Princeton Municipal Airport
AWOS Siting

Memorandum

Date: 6/3/2021
To: Michele McPherson
Copy to: File
From: Andrew Zielike
RE: Preliminary AWOS Siting – ALP Proposed Location

**Princeton Municipal Airport
Existing AWOS**

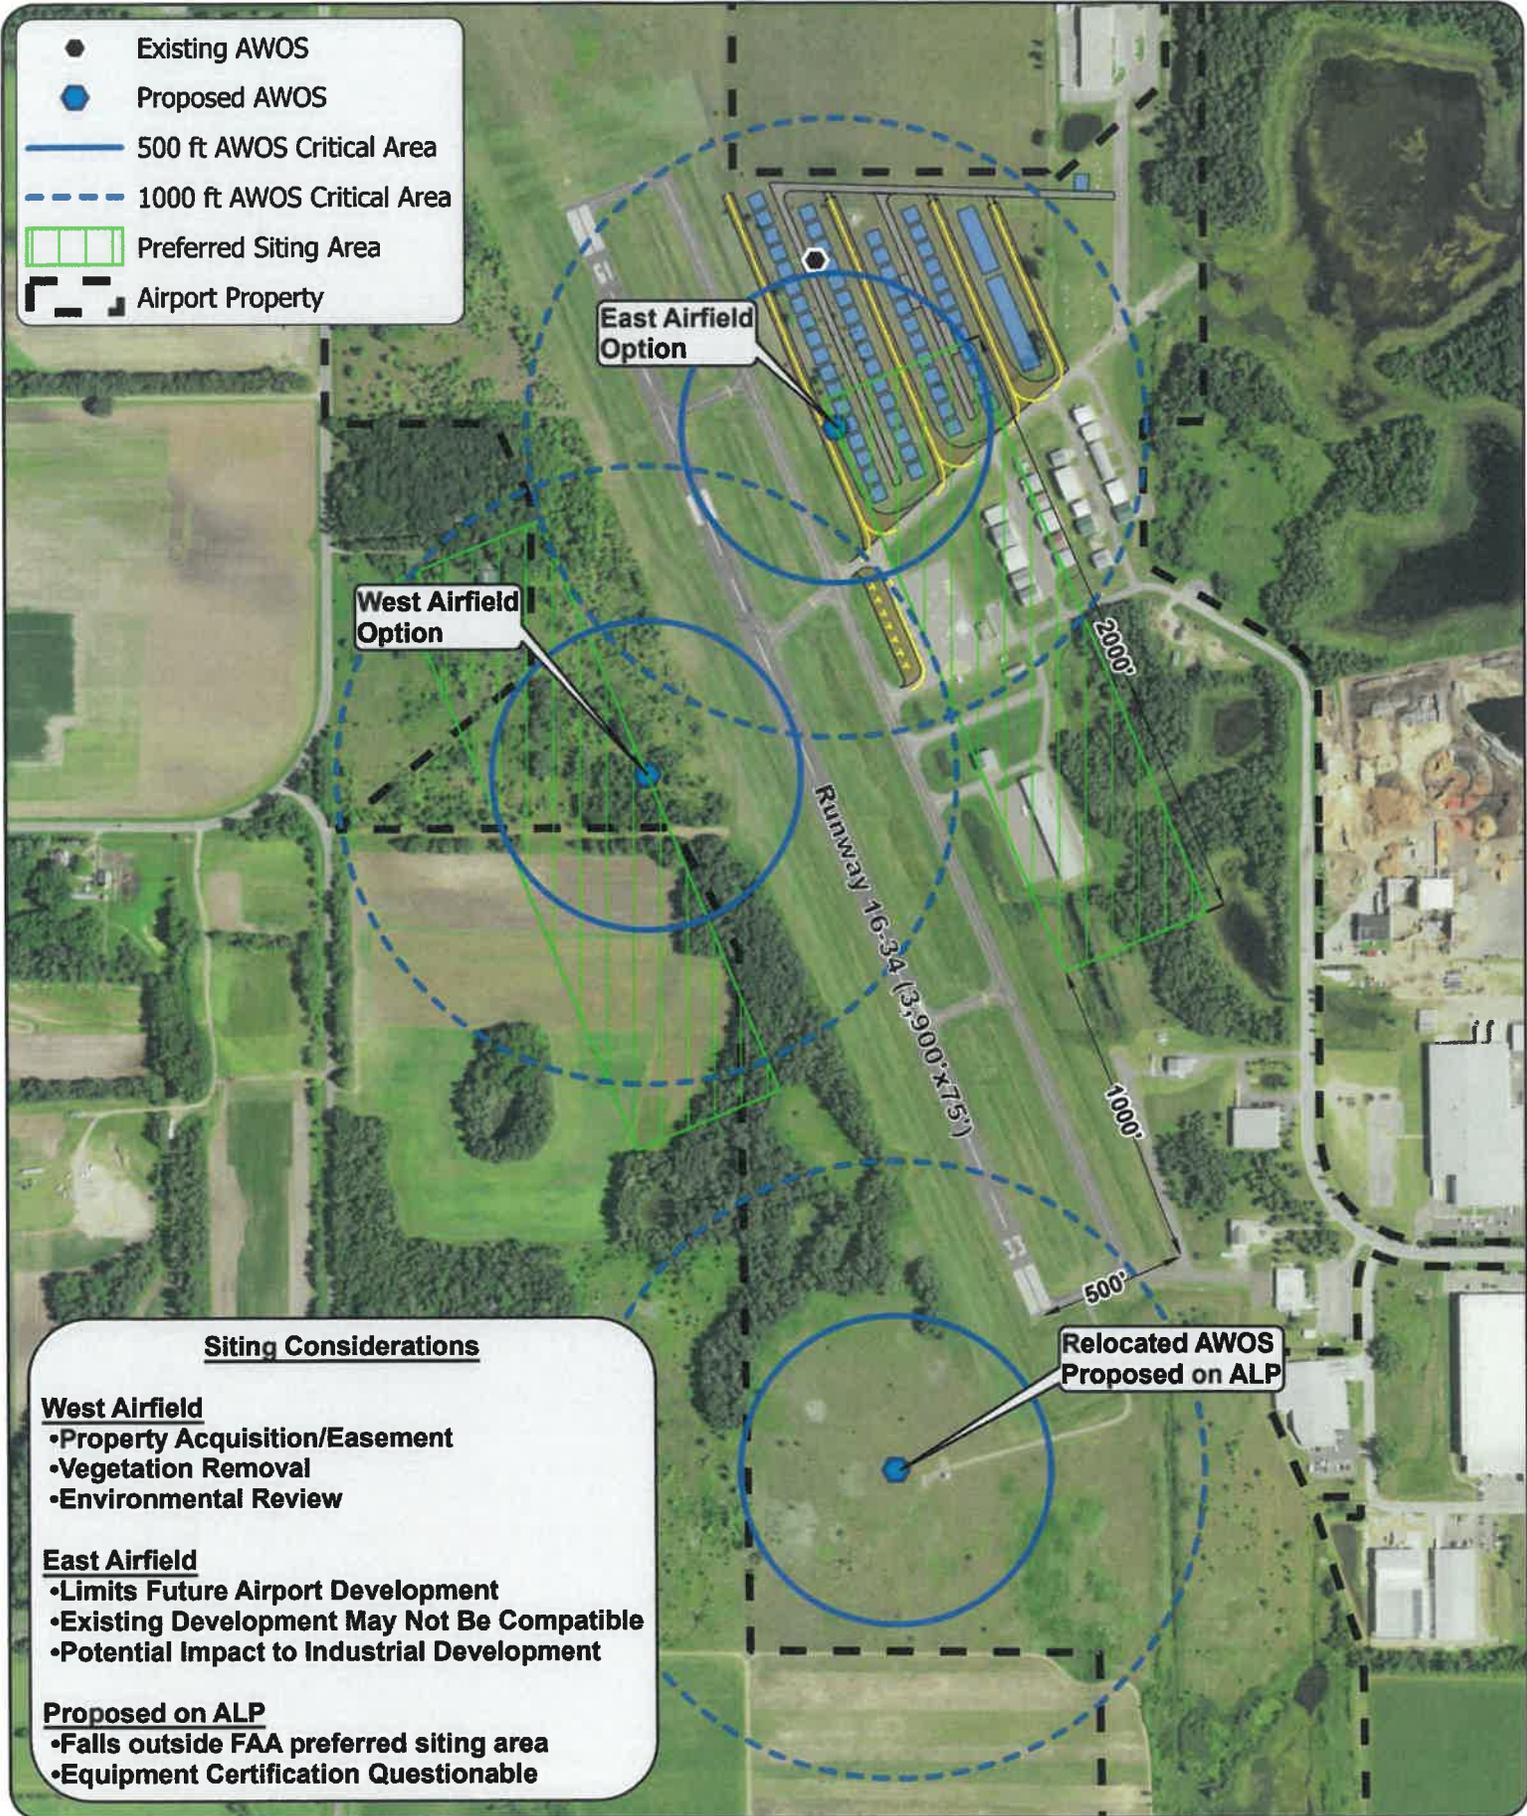
Siting Considerations

West Airfield

- Property Acquisition/Easement
- Vegetation Removal
- Environmental Review

East Airfield

- Limits Future Airport Development
- Existing Development May Not Be Compatible
- Potential Impact to Industrial Development

Proposed on ALP

- Falls outside FAA preferred siting area
- Equipment Certification Questionable

I have reached out to Mike Hartell from MnDOT regarding the proposed AWOS location on the ALP. Their concern rests with the ability to certify the new equipment that is not within the FAA siting area as they have had difficulty certifying other AWOS systems sited outside this area in recent years. MnDOT will only participate in an AWOS relocation that would be certified. The sense I got from the conversation was that MnDOT is resolute on their position and being a key player in the process, this would be a challenging path with no guarantee of a desirable outcome. Below are some highlights from the conversation:

- In MnDOT's experience, the FAA has been steadfast in requiring AWOS systems be sited within 1,000-3,000 feet from the runway end that has lowest visibility.
 - MnDOT has tried to relocate other AWOS systems outside of this area and have faced issues trying to certify them.
- Mike stressed the importance of having the AWOS siting meet those standards as it provides pilots the best information as to what they will experience where they will touch down.
- Mike said the airport should determine a location that meets siting standards or as close to standards as possible and then approach them to work through the process.
- MnDOT currently owns the system. I asked if they could check whether the system would need to be replaced or just relocated. I will update you when I have more information.

After review, we would not recommend pursuing the AWOS relocation as depicted in the ALP. The siting criteria is designed to help ensure weather information provided to pilots accurately represents what is experienced near the touchdown area on the runway, and this is likely what MnDOT and the FAA will be focused on achieving. Additionally, pushing forward with this location will likely be a substantial amount of effort, met with resistance and no guarantee of certification.
